MEMORANDUM

RE: Public hearing for redevelopment of Breezeway Motel

Zoning Map Amendment (Z-18-00539)

Figure 6: Open Space

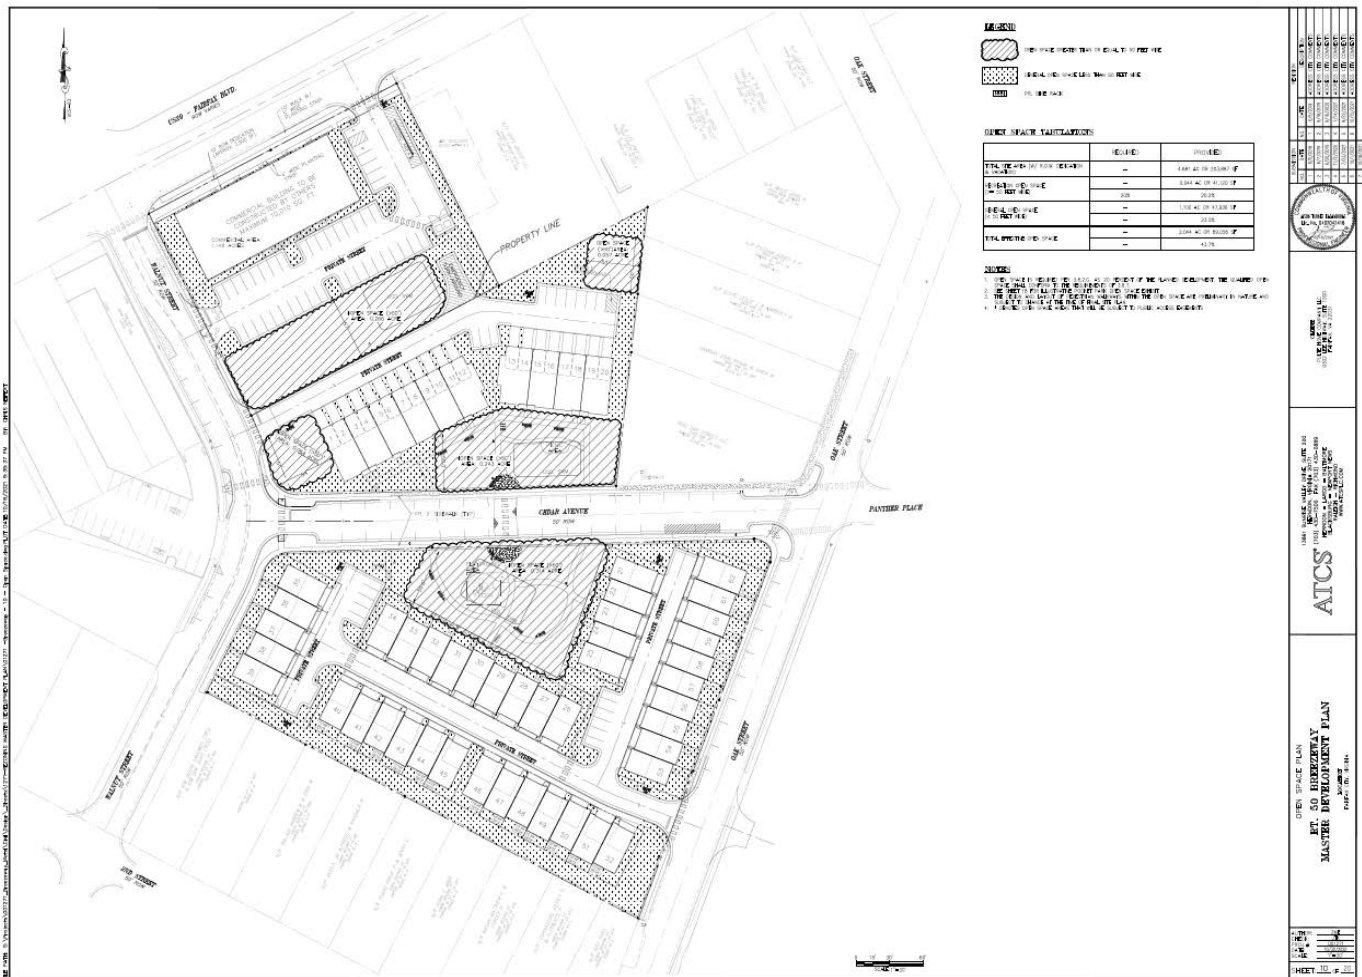
The applicant has also provided open space that is at least 60% contiguous, which includes any recreation and open space bisected by a local street. The applicant is proposing to install a mid-block pedestrian crosswalk on Cedar Avenue that connects the north and south side of the development. At this connection point on the north side of Cedar Avenue, the applicant proposes a pocket park with a plaza, benches, sidewalks, and picnic area. On the south side of Cedar Avenue, the applicant proposes a pocket park with a plaza, benches, sidewalks, tot lot with seating area, and a bicycle rack.

Figure 7: Transitional Yard

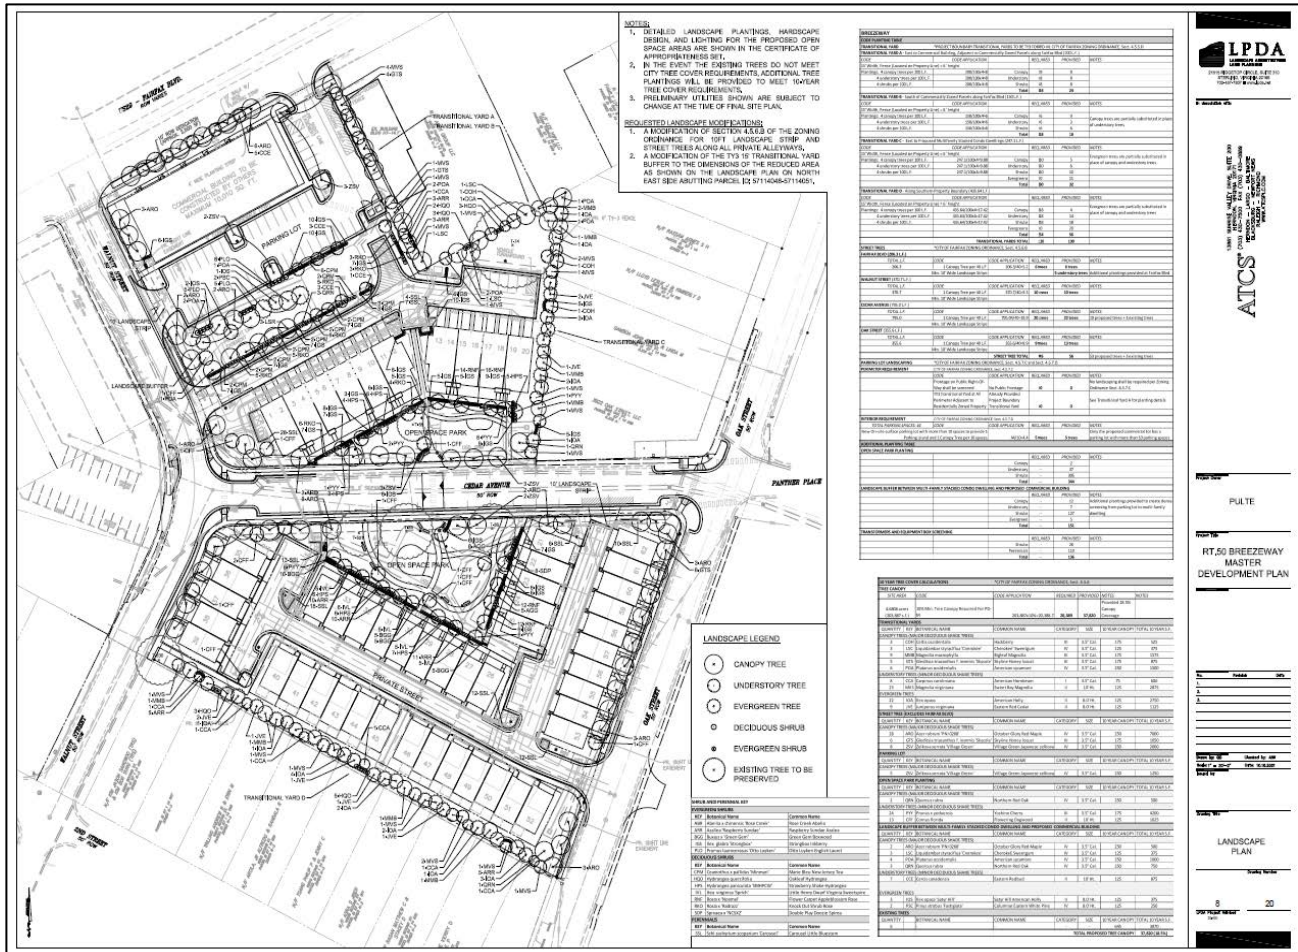
Staff recommended that the applicant use an evergreen or a similar planting to mix in with the required trees as a buffer to the existing homes on Oak Street and Second Street because evergreen trees maintain its green foliage year-round, grow fast and can provide screening and privacy between uses. Section 4.5.5.D of the Zoning Ordinance provides the minimum tree plantings as well as the minimum fence or wall height of the TY3 transitional yard specifications along the Subject Property’s boundaries. Table 3 (next page) provides the TY3 requirements and what the applicant has submitted in the Master Development Plan.

A transitional yard buffer of 15 feet (TY3) is required along the site area boundary. Transitional Yard A is approximately 200 feet in length. The applicant is seeking a modification to reduce the width from 15 feet to 9 feet adjacent to an existing commercial use in the CR Commercial Retail district. The applicant intends to maintain the required fencing, quantity, and type of plant species along this boundary line but would reduce the width of the transitional yard. The applicant is proposing a six-foot fence with 8 canopy trees, 8 understory trees and 8 shrubs along the property line.

Figure 8: Pedestrian Movement Plan

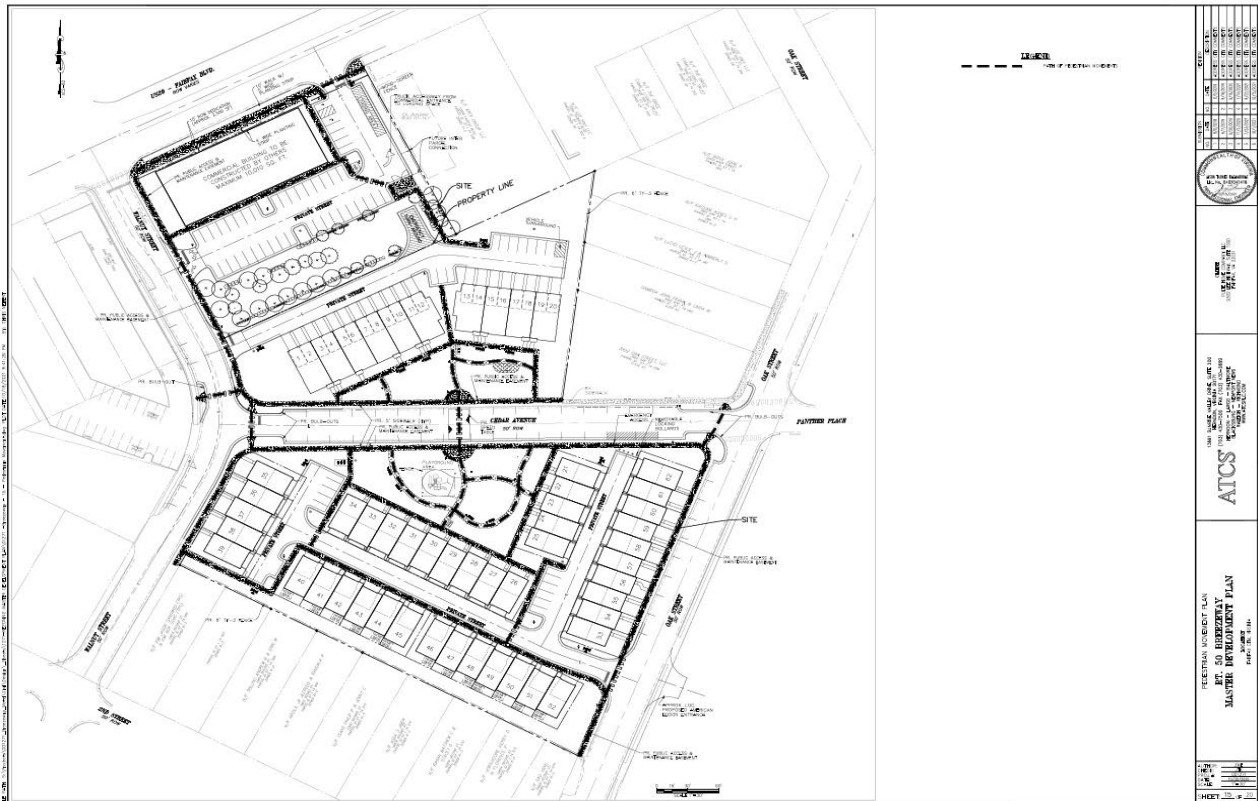
The applicant is seeking a modification to the sidewalk requirement for both sides of all streets internal to the site. This modification applies to all private streets within the proposed development. All units have a connection to five (5) foot sidewalk in the front of the unit or in the case of Units 40-52 to the private street creating a continuous pedestrian connection throughout the site. The Master Development Plan depicts a pedestrian connection from the two-over-two condominiums near the eastern property line and a pedestrian connection along Walnut Street to the commercial area. There is an existing crosswalk on Walnut Street and Fairfax Boulevard, and an existing crosswalk from the south side to the north side of Fairfax Boulevard. In Phase Three (Interim Plan), the applicant proposes to keep the existing sidewalk along Walnut Street in its existing condition and to remain open for pedestrian access until the final streetscape improvements are completed in Phase Four. In addition to keeping the existing sidewalk on Walnut Street, the applicant proposes a ten-foot asphalt trail in Phase Three until the final streetscape improvements are made in Phase Four. As recommended by the Multi-Modal Plan, a ten (10) foot wide sidewalk or multiuse path on Fairfax Boulevard would be installed in Phase Four of the project.
